PCN# 20130709002
Packing Material change for Select Devices on
WSON Package using 8mm Tape Width
Change Notification / Sample Request

Date: 7/23/2013
To: MOUSER PCN

| Title: | Packing Material change for Select Devices on WSON Package using 8mm Tape Width | | | | |

Current Packing for full SPQ (3ku) – 13 inch reel diameter

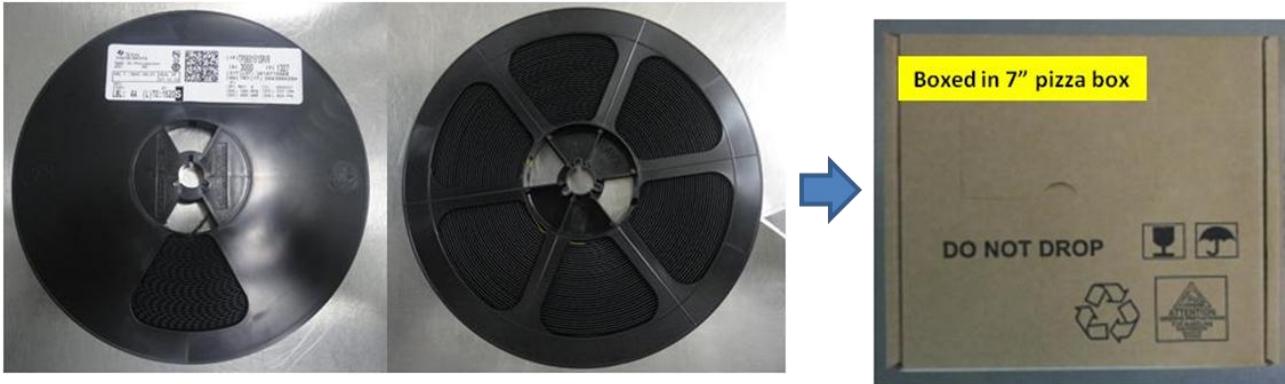
Packing Material change for Select Devices on WSON Package using 8mm Tape Width. Pack material differences are shown below:

Proposed Packing for full SPQ (3ku) – 7 inch reel diameter

| Pack BOM | Current for Full SPQ | | Proposed for Full SPQ | |
|----------|----------------------|--------------------------|-----------------------|-------------------------|
| Reel | 4203160-0019 | C-Pak 13" dia, 8mm width | 4203839-0005 | C-Pak 7" dia, 8mm width |

Attachment A: Reel Drawing
(TI P/N: 4203839-0005)

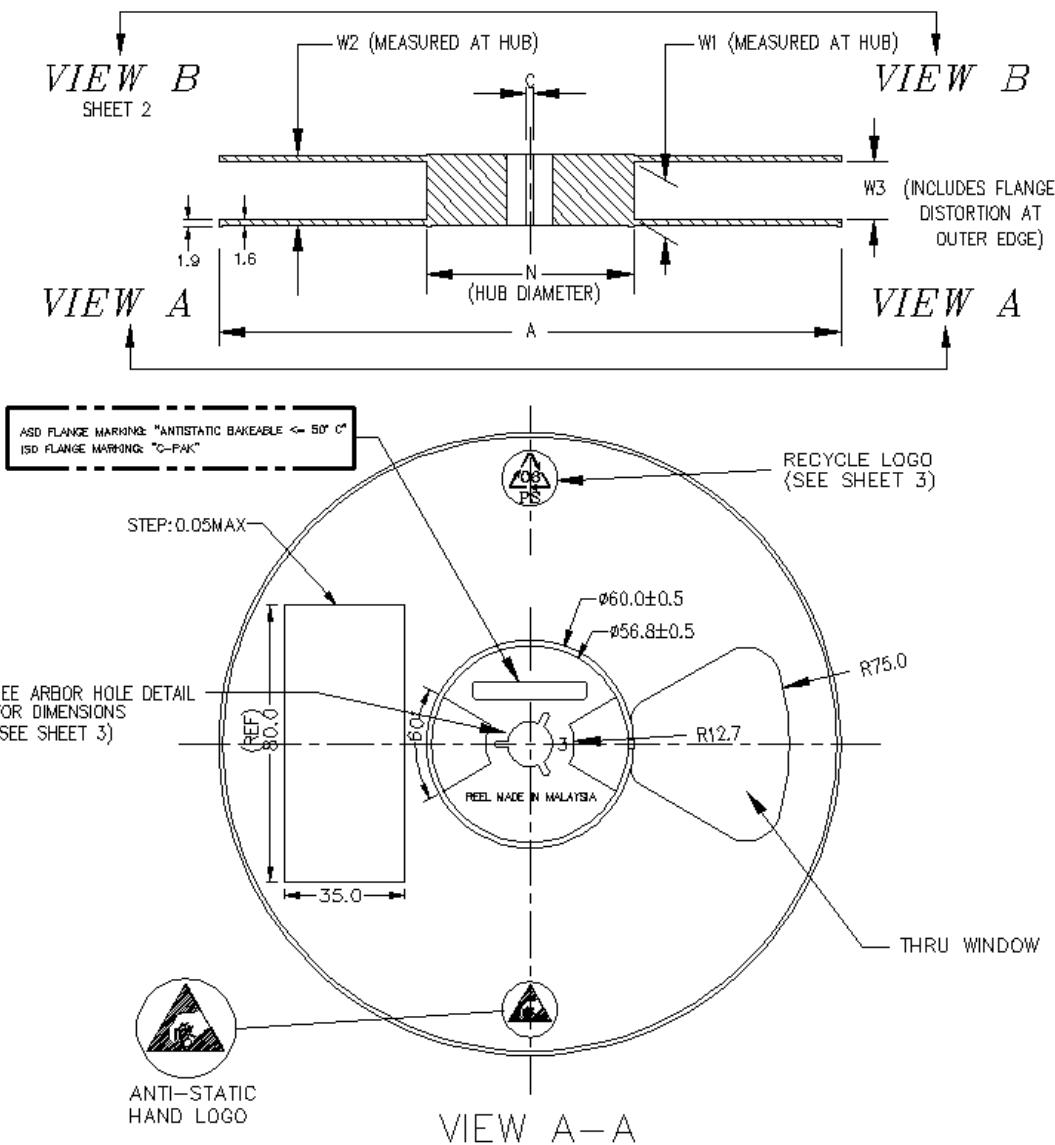
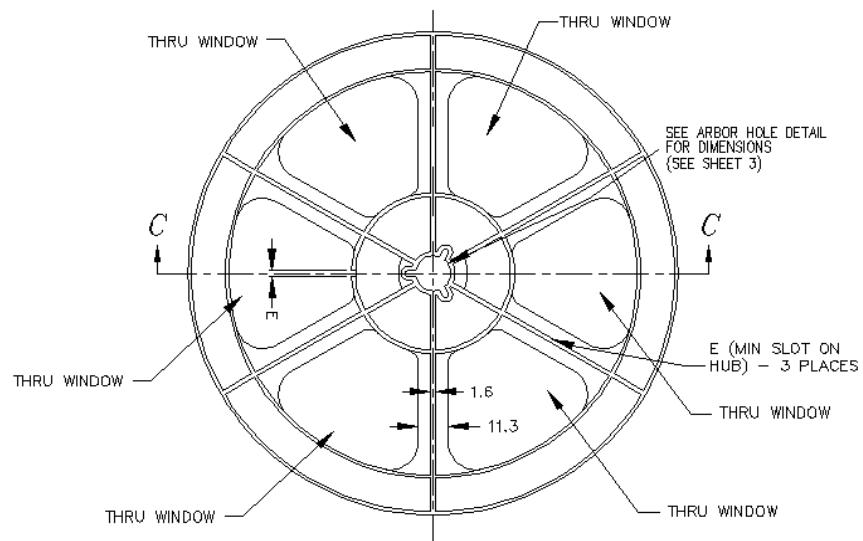
Qualification summary for 7" diameter, 8mm width

Supplier: **C-PAK**
 Vendor Part No: **7E2M08BKCP/ASL**
 Material: **Anti-static Dipped PS**
 Designed per EIA-481B
 Intrinsically Static Diss.
 Weight (g)
 Color:
 TI Part No:
 Result:
 Date:

| MAT'L REV LTR | PART NUMBER | SUPPLIER PART NUMBER | MATL TYPE | ESD TYPE | TAPE SIZE (MM) | A (MAX.) | B (MIN.) | C (± 0.2) | D (MIN.) | E | N (MIN.) | W1 | W2 (MAX.) | W3 (MIN./MAX.) |
|---------------------|--------------|----------------------|--------------|-------------|-------------------|-------------|-------------|--------------------|-------------|---------------|-------------|---------------|--------------|-------------------|
| A | 4203839-0005 | 7E2 M08 BK CP/ASL | PS | ASD | 8.0 | 180 | 1.5 | 13.0 | 20.2 | 4.0 ± 0.1 | 60.0 | 8.4 +1.5/-0.0 | 14.4 | 7.9/10.9 |
